Subject: FW: DRAFT Regulatory Issue Summary - Applicability of ASME Code Case N-770-1 to Branch Connection Butt Welds
Attachments: Branch Nozzle Weld Sketch.pptx

I have a question regarding the DRAFT Regulatory Issue Summary detailing the staff's position regarding the applicability of ASME Code Case N-770-1, as conditioned by 10CFR50.55.a, to branch connection butt welds.

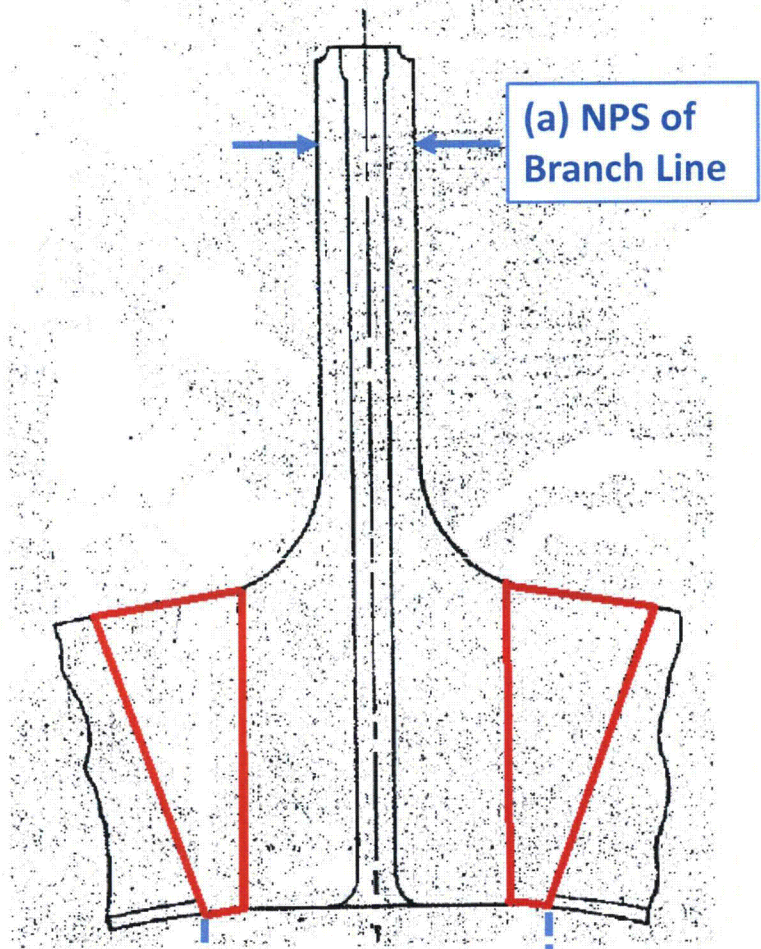
For butt welds using Alloy 82/182 material that join a branch connection nozzle to a run pipe, is it intended that "NPS 2" or greater" refers to the nominal pipe size of the branch line or does the size of the opening in the run pipe and the corresponding diameter of the weld that connects the branch connection nozzle to the run pipe need to be considered in determining the "NPS 2" or greater" threshold for volumetric inspection of the branch connection nozzle to run pipe weld? Please refer to the attached sketch.

(a) NPS of Branch Line

(b) Diameter of Nozzle to Run Pipe Weld
